Development Plan Hearing Input from Halethorpe Improvement Association Regarding the Proposed Southern Crossroads Development

PAI Number: 13-0239

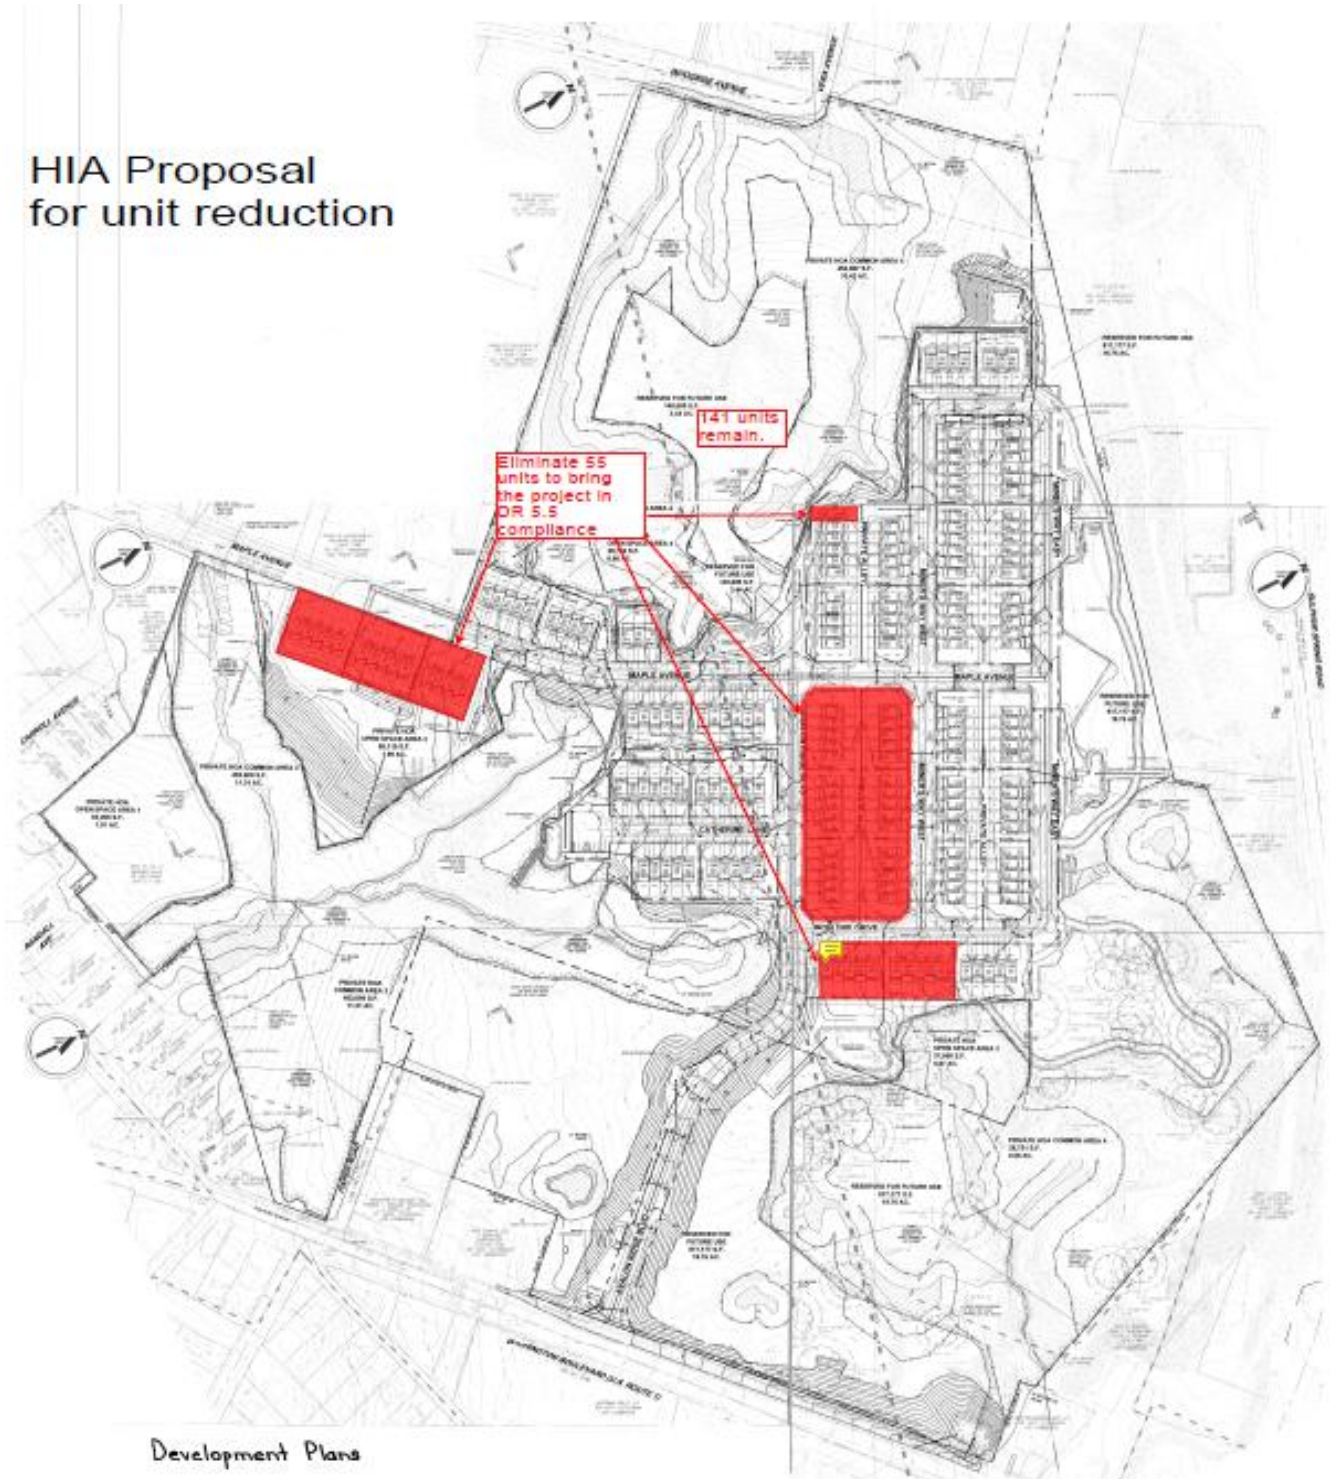
If Maple Avenue were closed to through traffic from the proposed development, that would drastically lessen the negative impacts of this development on the existing community. If Maple and Summit Avenues were changed to have No Parking zones that would in effect increase the width of these roads, but doing so would be an astounding inconvenience and a flagrant insult to existing residents.

In addition, HIA is concerned about not only construction traffic, but also demolition traffic using Maple and Summit Avenues. Residents on these avenues have already experienced an increased flow of large trucks entering and exiting the property to be developed. As illustrated, these are narrow roads that are not in the best of shape, and they have few to no sidewalks. HIA seeks assurance that the proposed new access road to the development be built first to accommodate all construction and demolition traffic.

HIA Overall Proposal

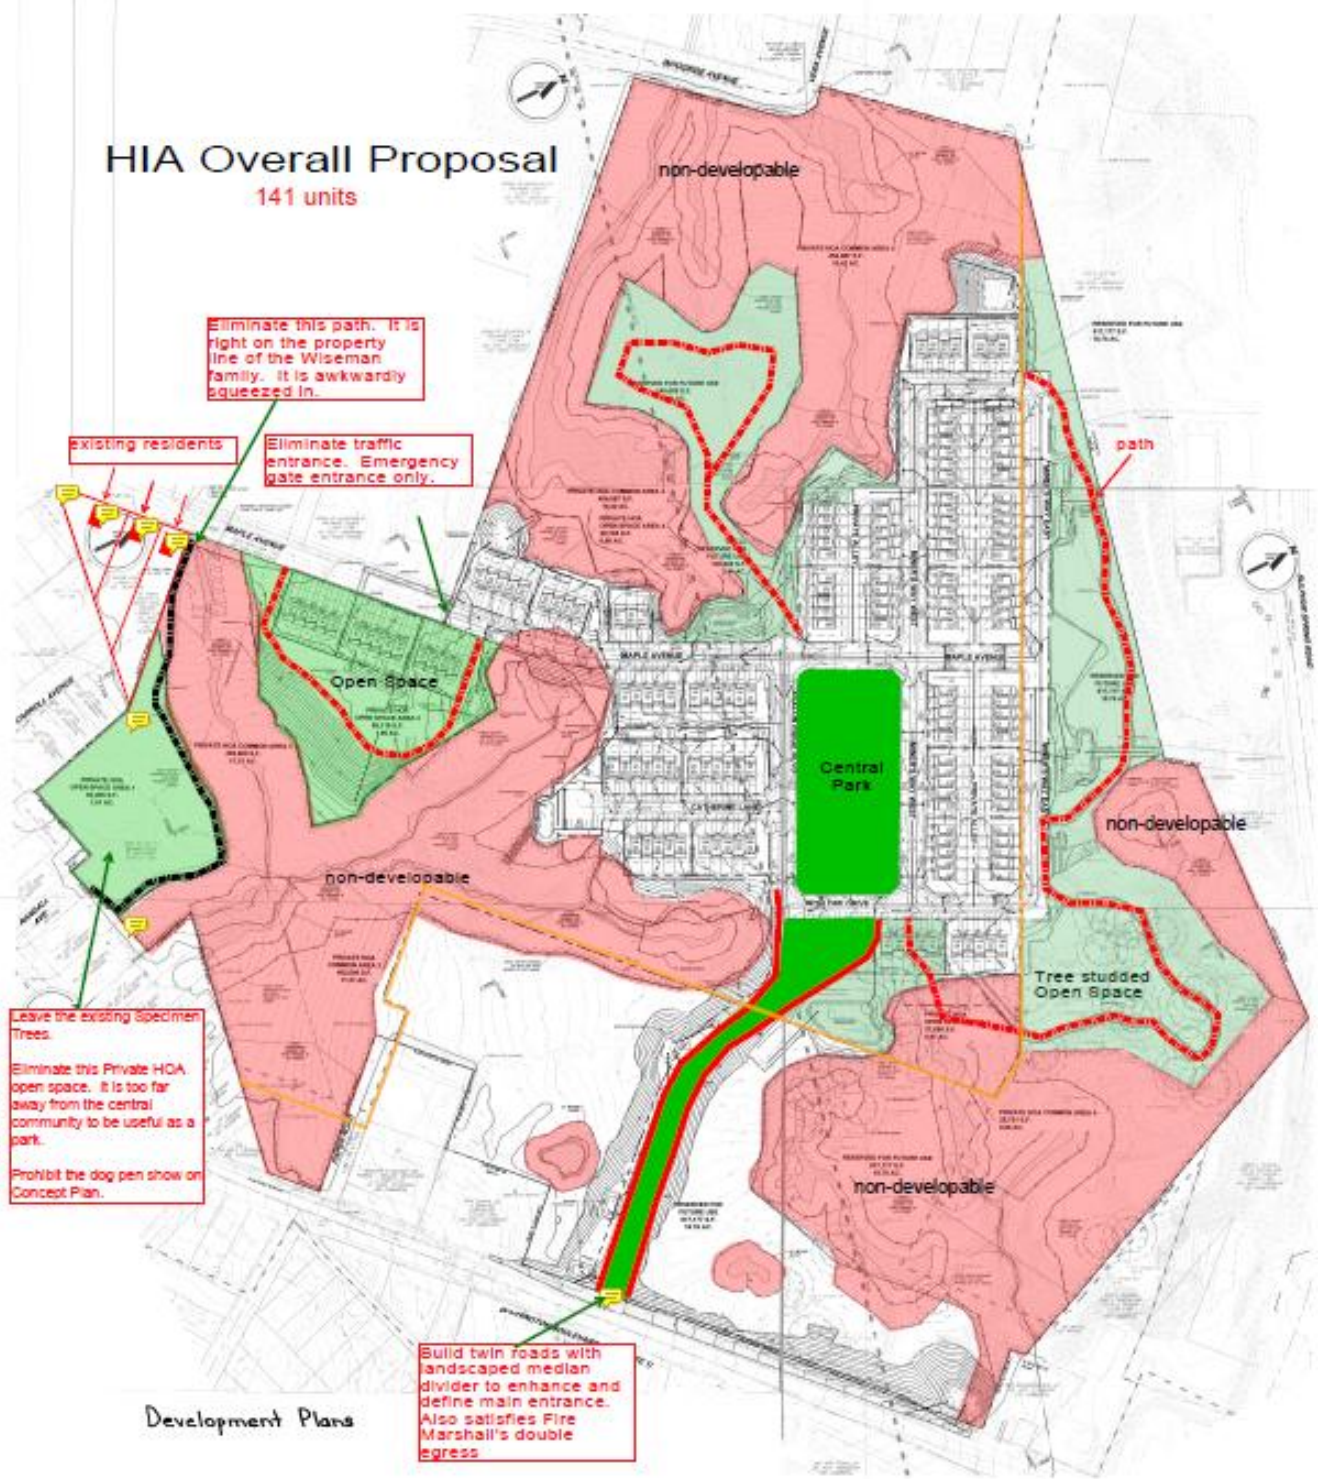
Eliminate this path. It is right on the property line of the Wiseman family. It is awkwardly squeezed in.

Eliminate traffic entrance. Emergency gate entrance only.

Leave the existing Specimen Trees.

Eliminate this Private HOA open space. It is too far away from the central community to be useful as a park.

Prohibit the dog pen show on Concept Plan.

Build twin roads with landscaped median divider to enhance and define main entrance. Also satisfies Fire Marshall's double egress

These proposals show compliance with the density specified in the Developable versus Undevelopable Acreage section above and show an increase in useable Open Space for the development. Congestion on Maple Avenue would be relieved (particularly at dismissal time for HES) with the removal of units 1-14. There is still a dense grid layout and a walled effect created by the remaining townhouses, but that would require a complete redesign to alleviate. Can the developer design a better development?
